UNIVERSITY OF FLORIDA
TRAINING REACTOR
LICENSE NO R-56
DOCKET NO. 50-83

SUBMITTAL OF RESPONSES TO NRC
REQUEST FOR ADDITIONAL INFORMATION
FOR THE CONVERSION FROM HIGH-ENRICHED
URANIUM TO LOW-ENRICHED URANIUM FUEL

**University of Florida Training Reactor, Facility License: R-56, Docket No. 50-83
Request for Change in Technical Specifications Approving HEU to LEU Conversion
With Responses to Requests for Additional Information**

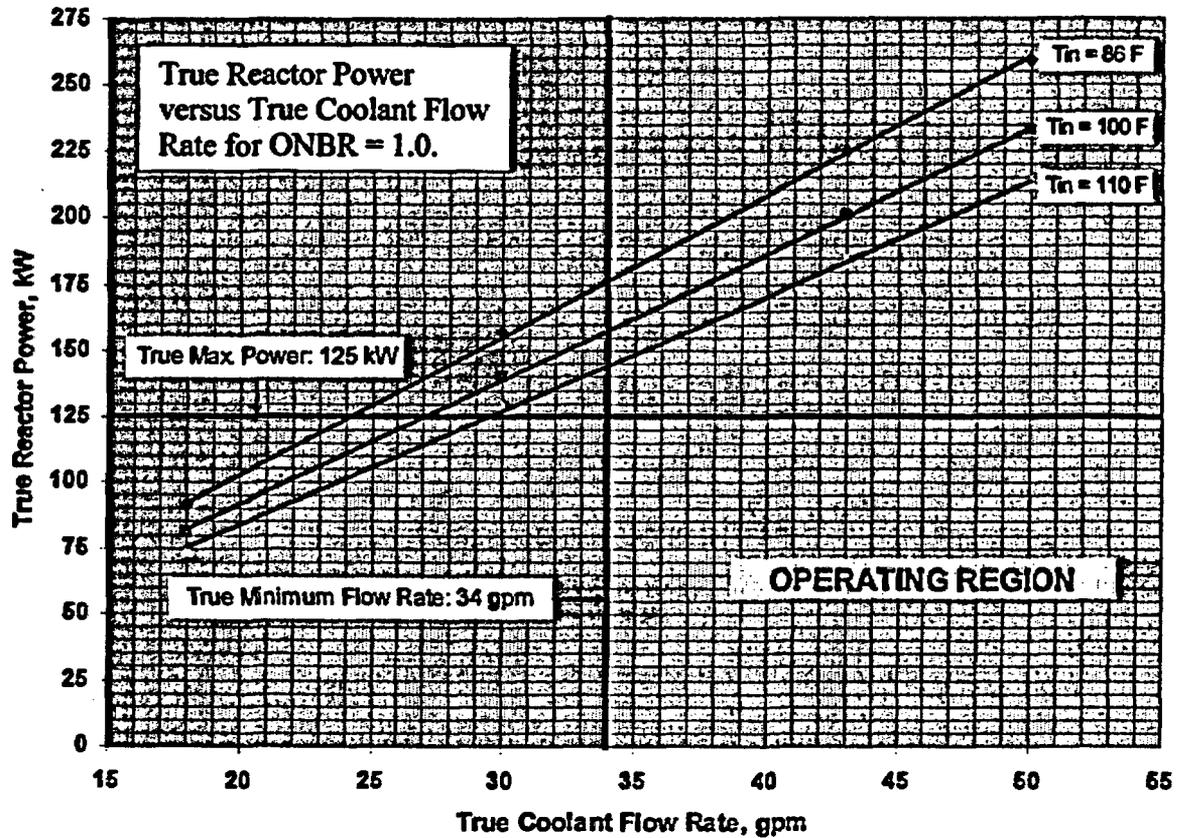
25. TS 2.1. Safety Limits. The regulations in 10 CFR 50.36 define safety limits (SLs) as limits upon important process variables that are found to be necessary to reasonably protect the integrity of certain of the physical barriers that guard against the uncontrolled release of radioactivity. Exceeding a SL means that there is a possibility that the physical barrier has failed. That is the basis for requiring Commission approval for reactor restart if a SL is exceeded. As pointed out in the SAR, fuel cladding is the physical barrier of concern. It is stated that the integrity of the barrier is protected if the cladding temperature is kept below the incipient melting temperature of 582°C for the 6061-aluminum cladding of the LEU silicide fuel (however, NRC has accepted an upper temperature for aluminum-clad fuel of 530°C based on blister formation temperature-see NUREG-1313, "Safety Evaluation Report related to the evaluation of Low-Enriched Uranium Silicide-Aluminum Dispersion Fuel for Use in Non-Power Reactors," Section 3.3.3). You have based your SLs on the prevention of localized boiling. This results in SL process variable values significantly below those needed to protect against clad blister.

As a result, in some cases, the accident analysis does not appear to support the technical basis for the SLs. For example, for the analysis of a step addition of reactivity of 0.6% dk/k into the core, the peak power for the LEU core with a SCRAM occurring is 320 kW. This would violate the SL in the proposed Technical Specification 2.1, namely, that "the power level shall not exceed 190 kW." Also, this result would indicate that the limiting safety system setting (LSSS) of 125 kW would not be in compliance with the regulations in 10 CFR 50.36(c)(1)(ii)(A) which states when a LSSS is specified for a variable on which a SL has been placed, the setting must be so chosen that automatic protective action will correct the abnormal situation before a SL is exceeded.

Please propose revised SLs and LSSSs, as needed, that support the conclusions in your accident analyses for reactivity insertions and loss-of-coolant or explain why the proposed values in your SAR are acceptable.

The value of 582°C will be changed to 530°C. This has no impact on the conclusions. The following figure provides information for selection of Limiting Safety System Settings (LSSS). Plotted in the figure are true reactor power versus true coolant flow rate for ONBR = 1.0 for three values of the coolant inlet temperature.

Based on the above figure, UFTR has decided on LSSS as follows: Power is 119 kW, coolant flow rate is 36 gpm, inlet temperature is 109 F, and outlet temperature is 155 F. These parameters were selected to account for uncertainties in measurements of the reactor power ($\pm 5\%$), coolant flow rate ($\pm 5\%$), and coolant inlet/outlet temperature ($\pm 1^\circ\text{F}$). Detailed analyses are provided in Appendix Q8.

Figure Q3-1 Relative Difference between the Peak-to-Average Power Width Profile

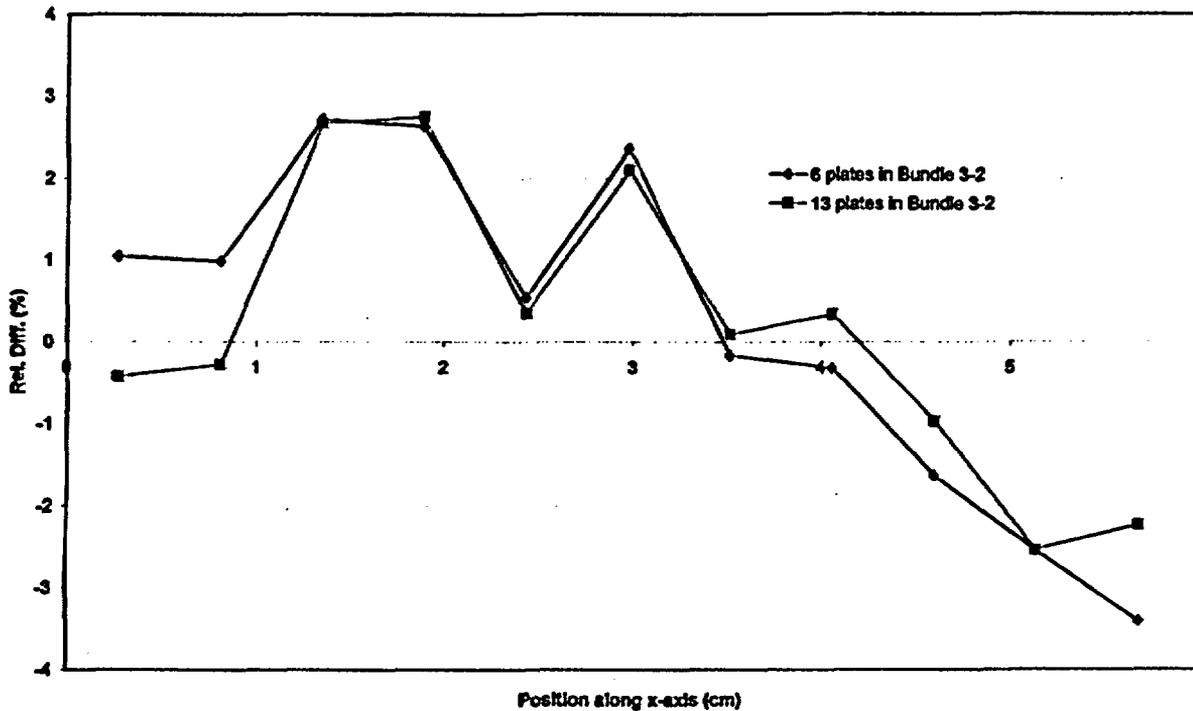
3. Section 4.5, Dynamic Design. Are any changes in fuel element location planned from the LEU reference core during the life of the core and if so, how does that affect the results of the safety analysis?

The changes in the peak-to-average ratio power width profiles for the critical plate was also studied as a function of the number of plates in the partial fuel bundle. Figure Q3-1 shows the relative difference in the peak-to-average ratio power width profiles between the nomina; case (10 plates) and the two cases.

The small changes in the power distribution presented in Table Q3-1, Table Q3-2 and Figure Q3-1 will have a minimal impact on the thermal-hydraulics analyses performed in the conversion submittal for the UFTR.
